Clock RMS Monitor

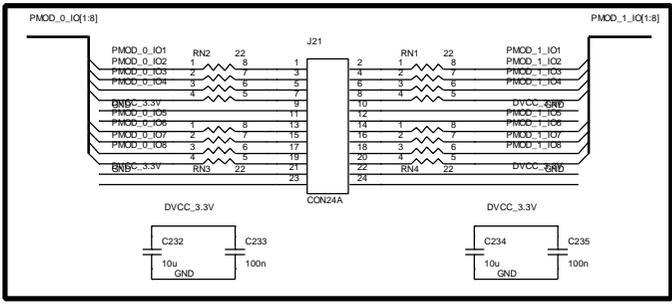
U21:-
 1) 100pF can be in parallel with C223.
 2) For 1.3M, Gain = 6.3, Intercept = 30mV,
 O/P at 7dbm will be around = 3.2V [close to 3.3V]
 3) Please check Maximum Input Level [dbm]
 It is between 6 to 7 dbm as per datasheet for 1.3MHz.
 Very Close.

Gyroscope Section

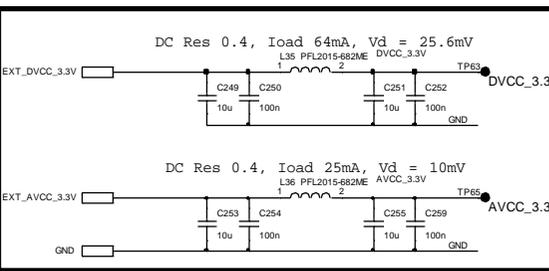
U23:-
 1) C221 and C224 is not recommended in datasheet.
 2) Decoupling of U22 is missing.
 3) How is the use in this system and where should it be placed on the PCB??

Microphone Amplifier Section

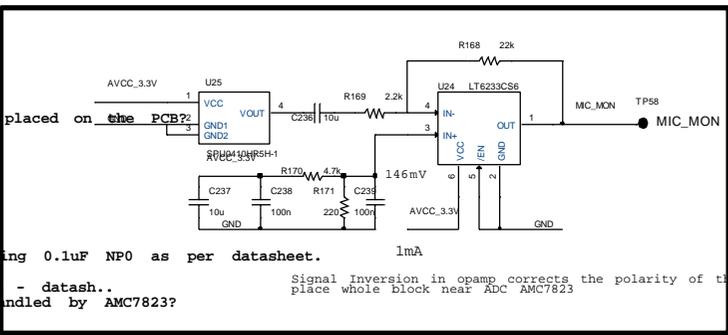
U25:-
 1) VCC pin should be decoupled using 0.1uF NP0 as per datasheet.
 2) Why is 146mV ref required?
 3) 0.1uF cap is suggested - Pg 19 - datash..
 4) How will bipolar signals be handled by AMC7823?
 5) Usage in system not clear

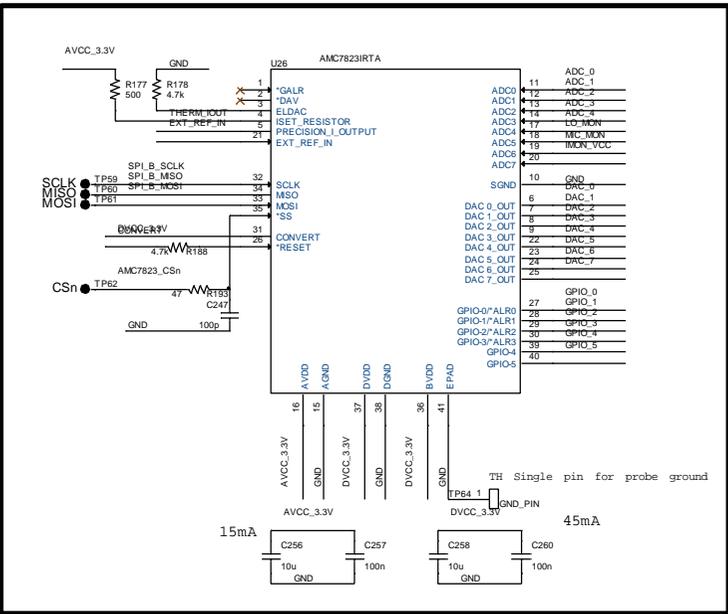
U26:-
 1) 10uF pin should be on EXT_REF_IN when internal ref selected.
